**RESPONSES TO THE TOWN OF NORTHBOROUGH PLANNING REVIEW COMMENTS
DATED APRIL 10, 2024**

**RESPONSES TO THE TOWN OF NORTHBOROUGH SITE PLAN REVIEW COMMENTS
DATED APRIL 11, 2024**

**NORTHBOROUGH
 FIRE STATION
 NORTHBOROUGH, MA**

DRAWING NO.:
C7.2
SHEET NO. 11 OF

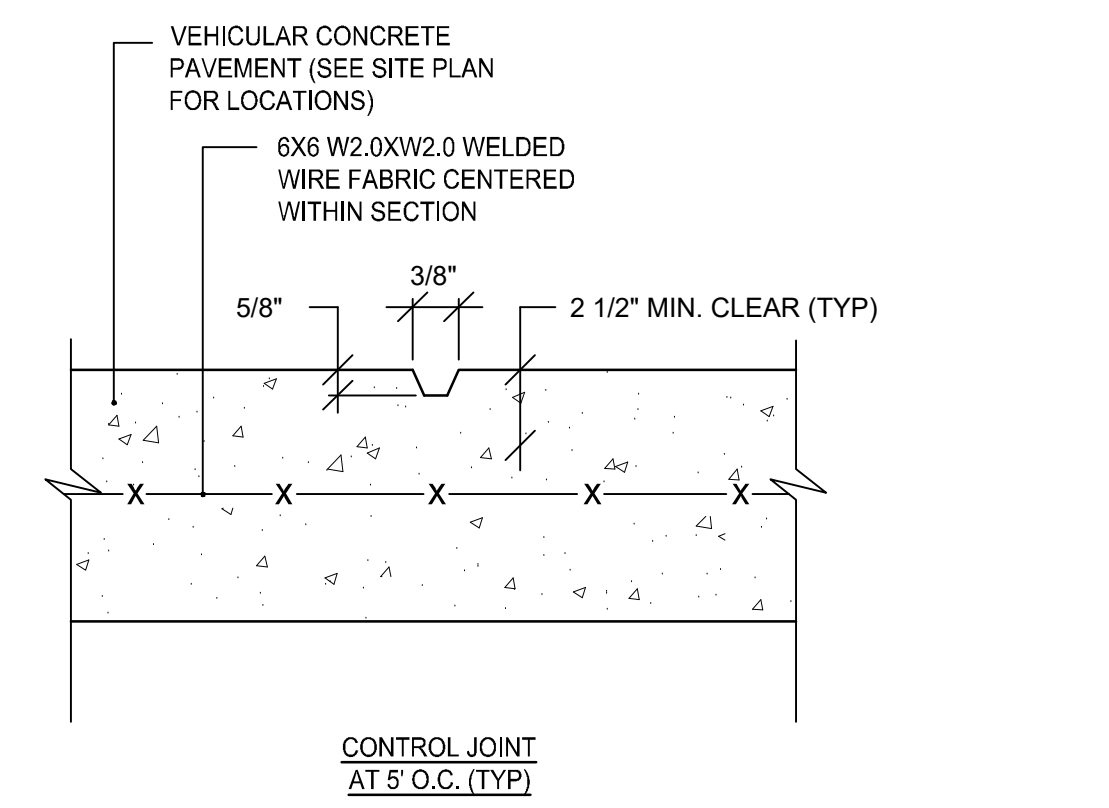
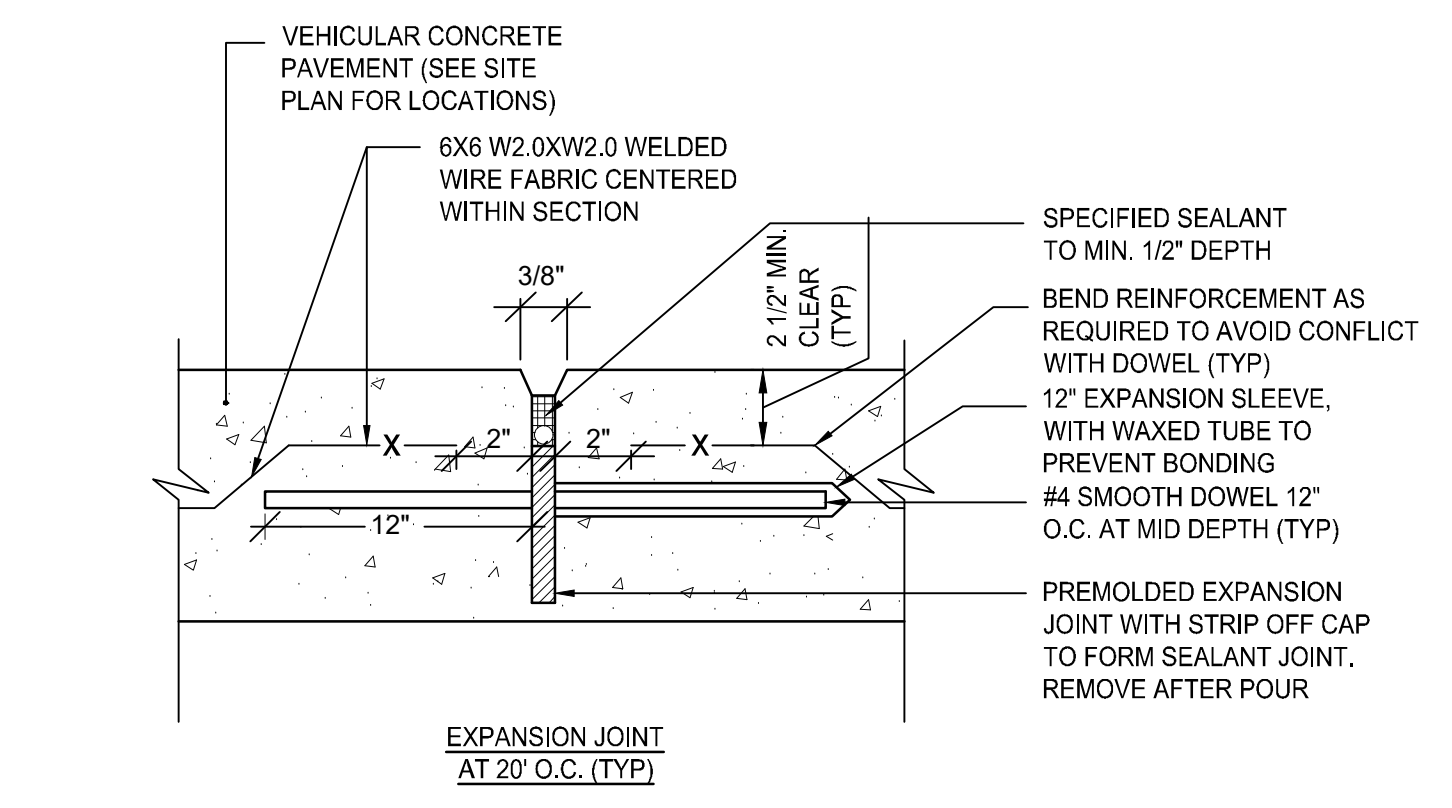
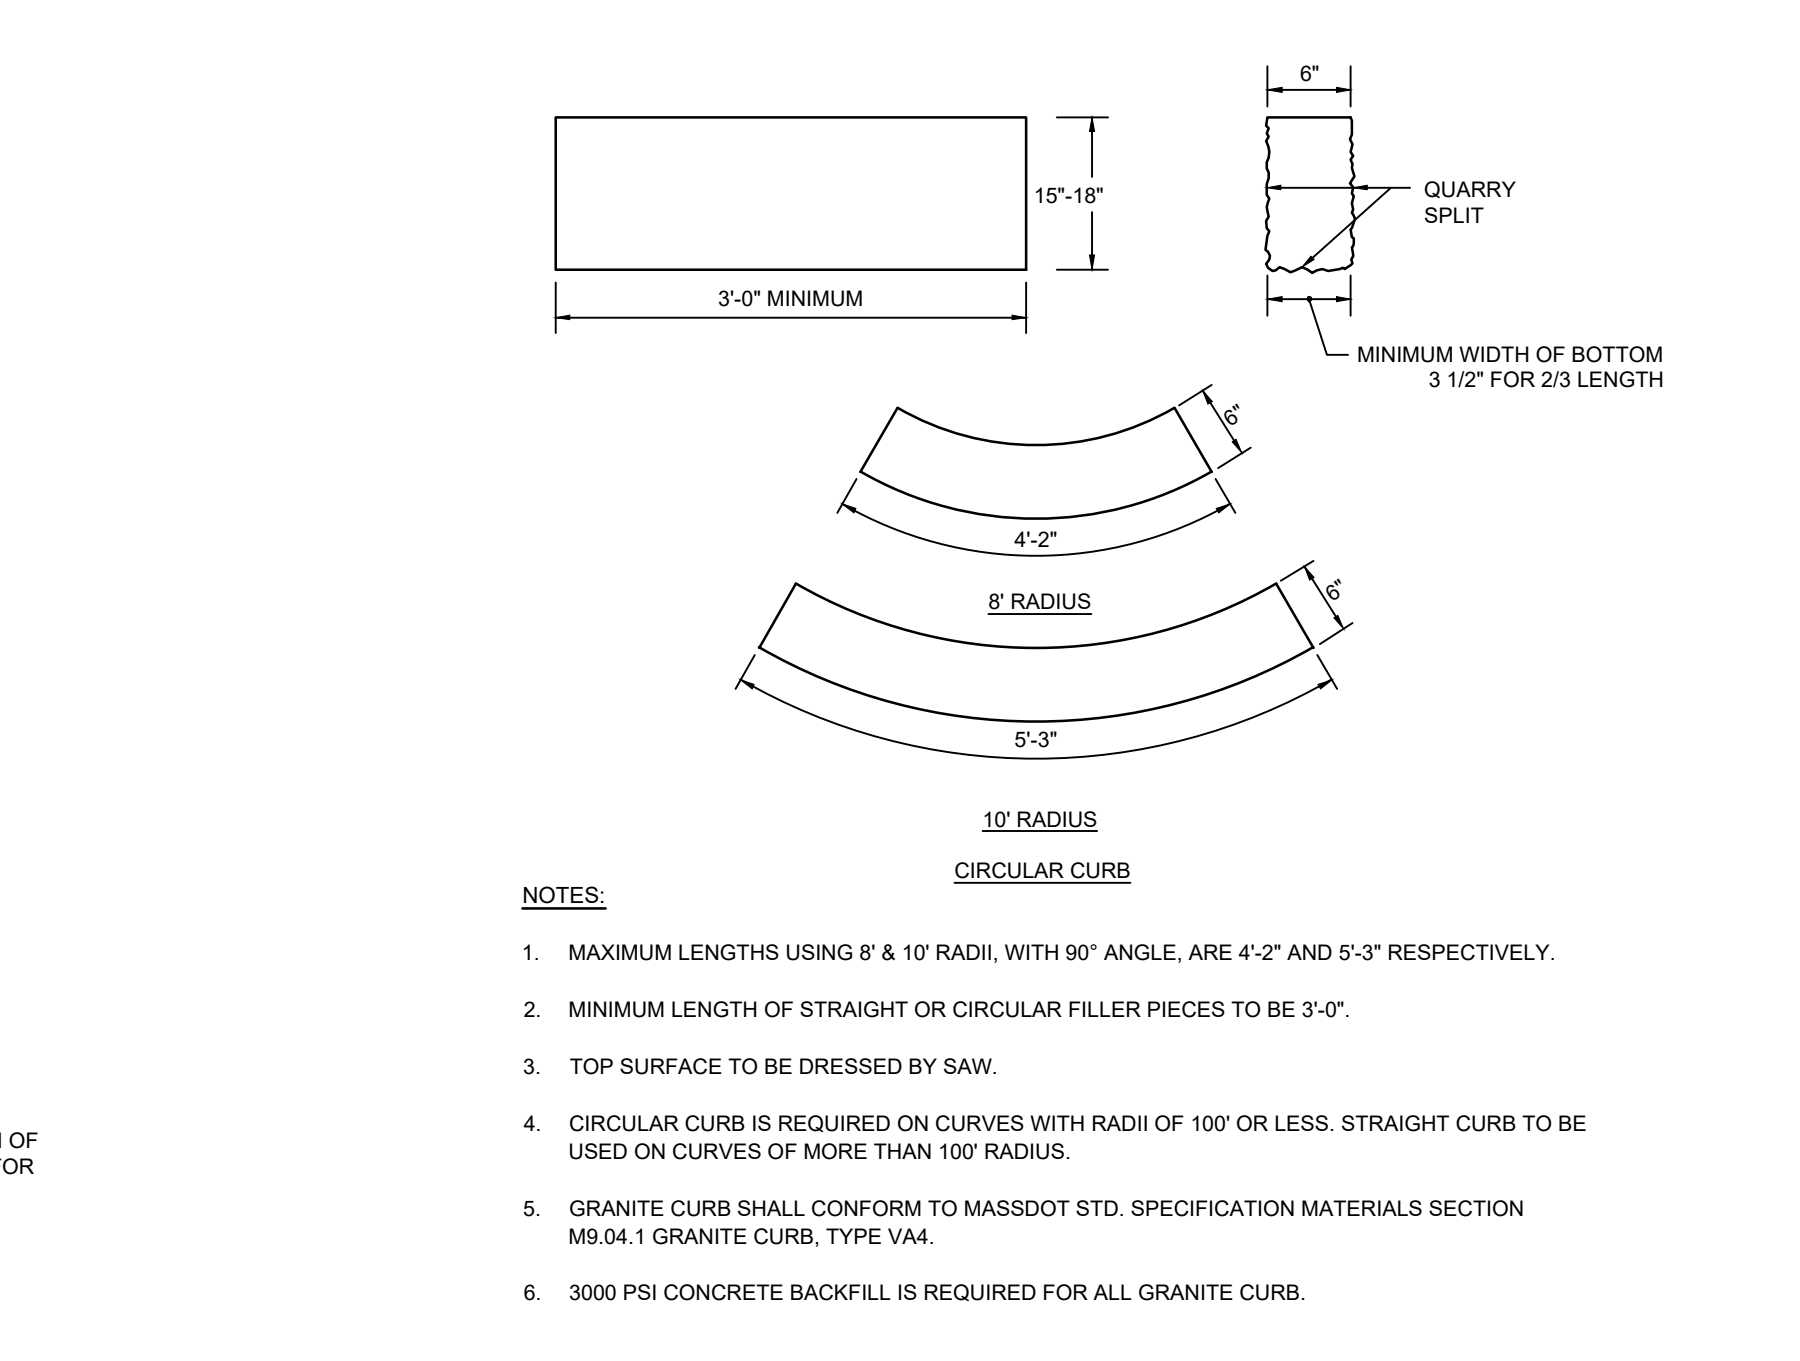
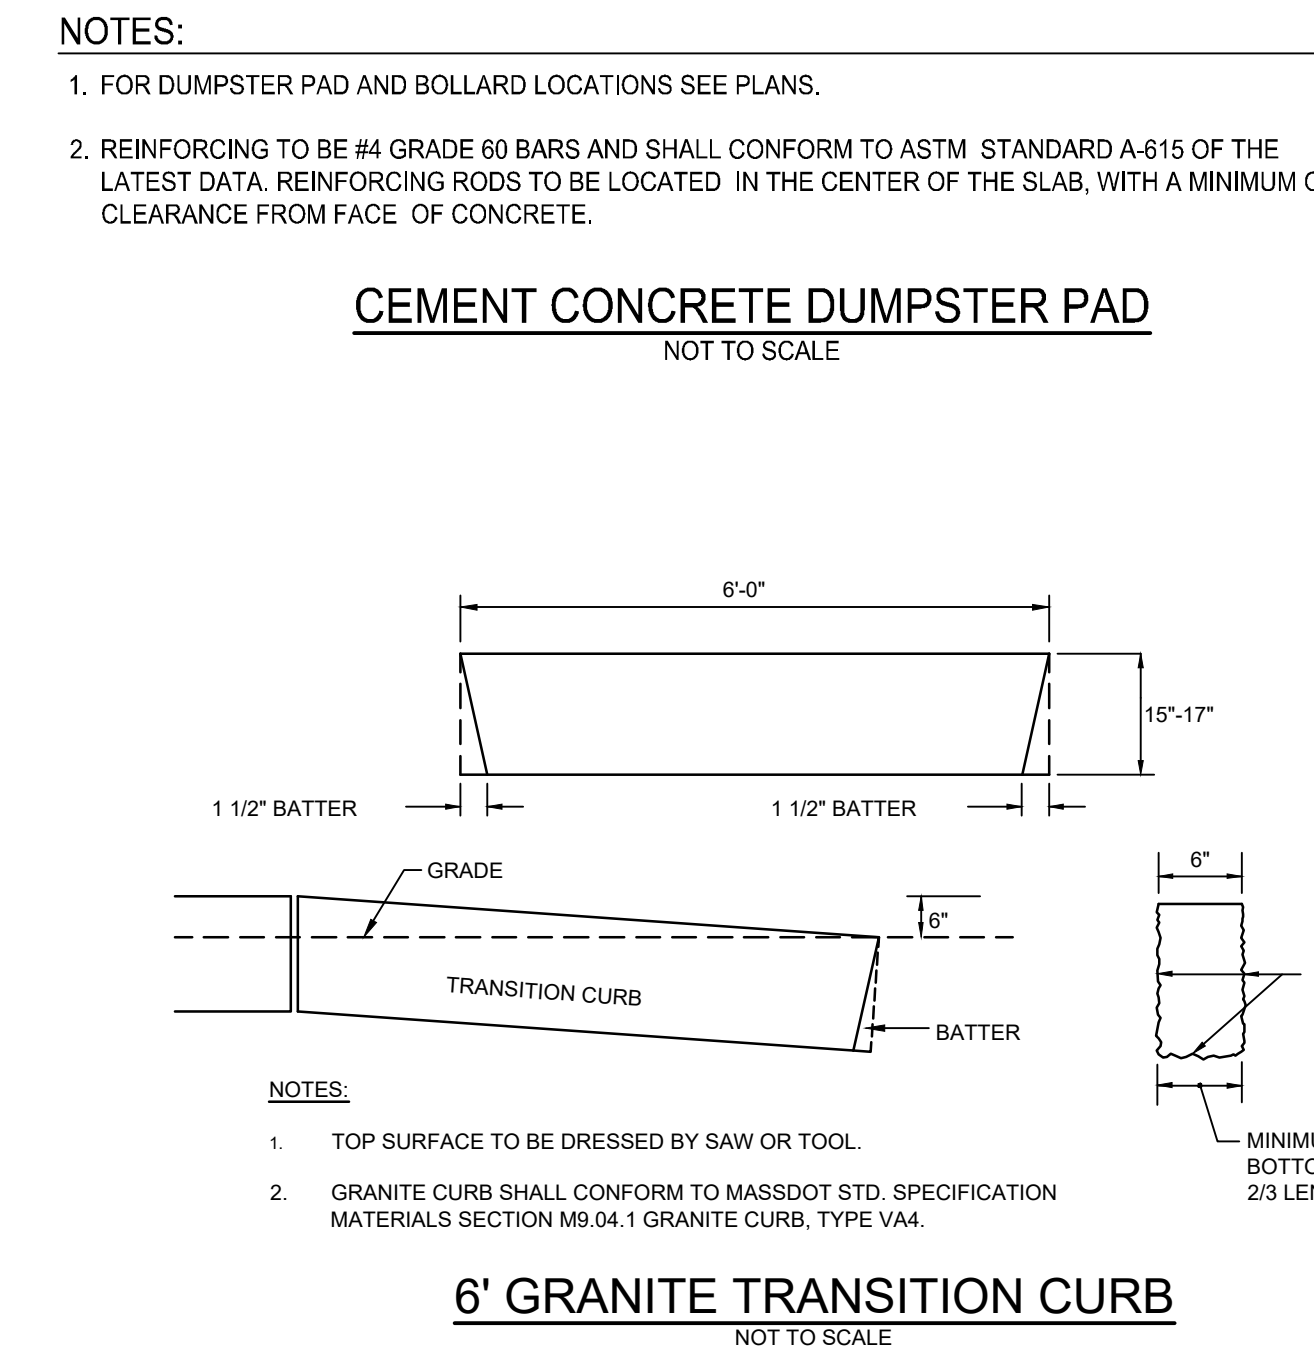
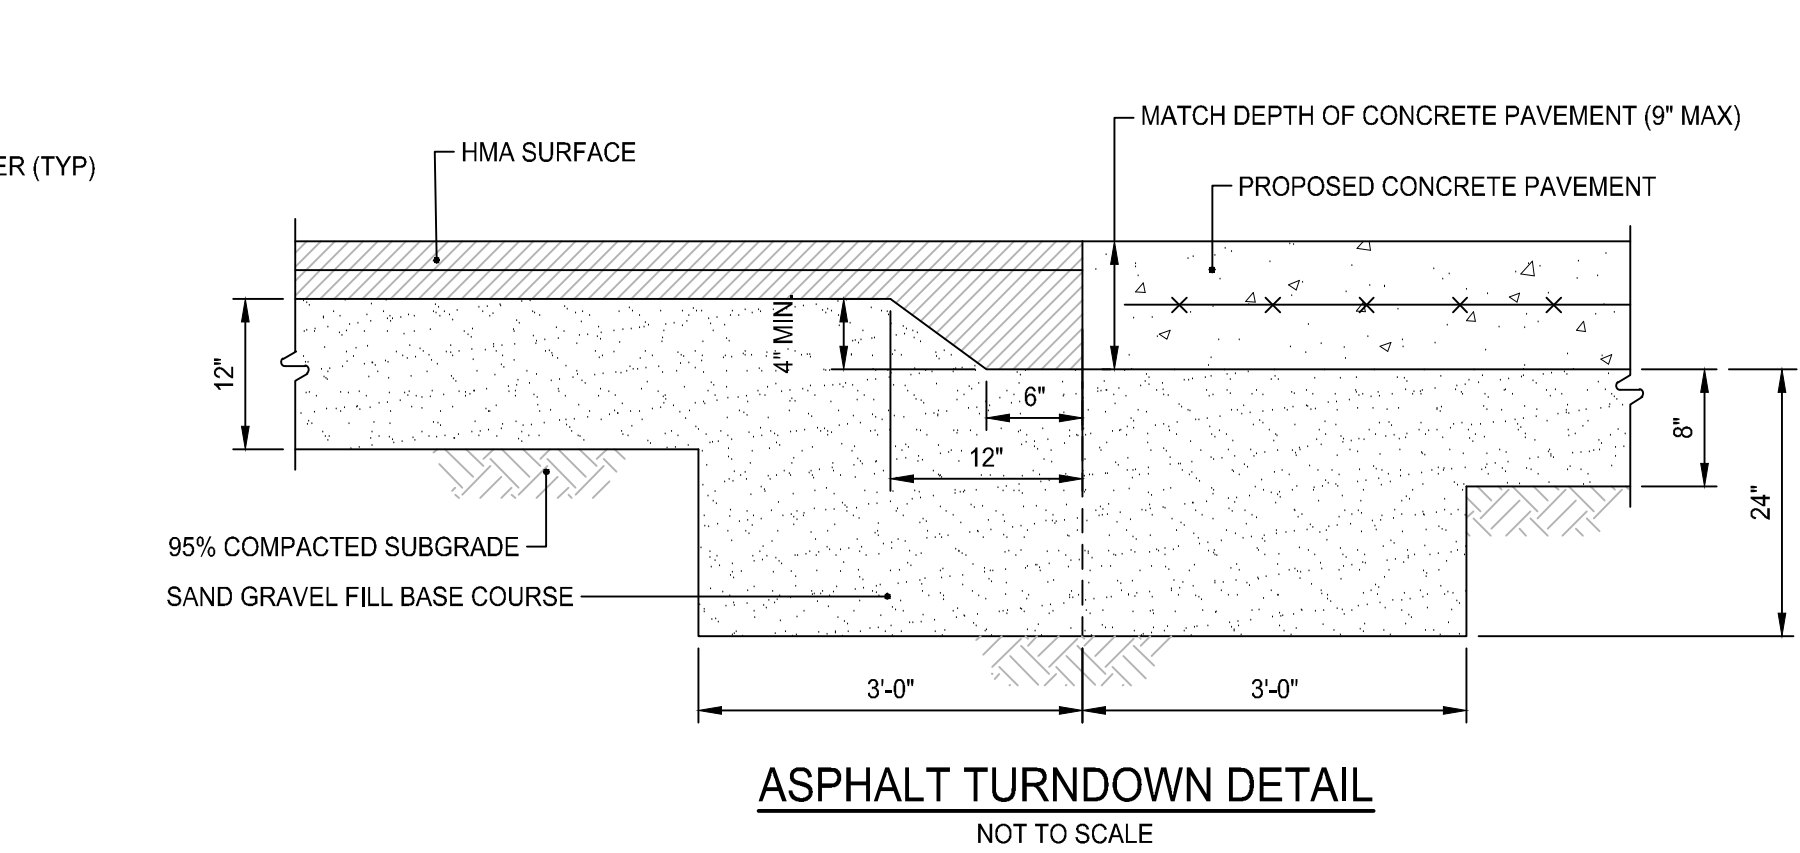
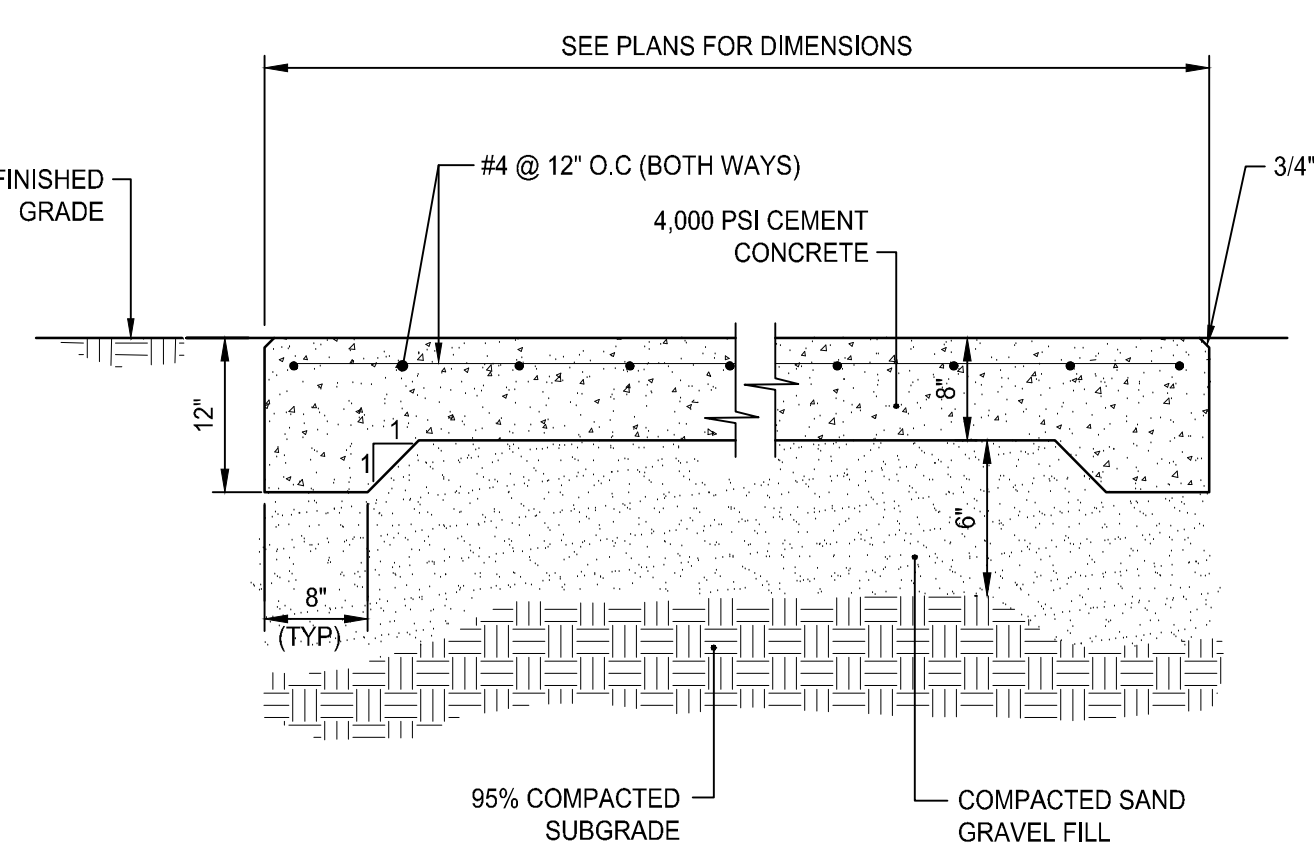
6. **COMMENT:** A detail for precast concrete wheel stops is shown on Sheet C7.2, however the location of these wheel stops is not depicted on the layout plan. Please clarify where the wheel stops will be located or remove the detail from the site plan to avoid confusion if they will not be installed on site.

RESPONSE: *The concrete wheel stop detail has been removed from the site plan.*
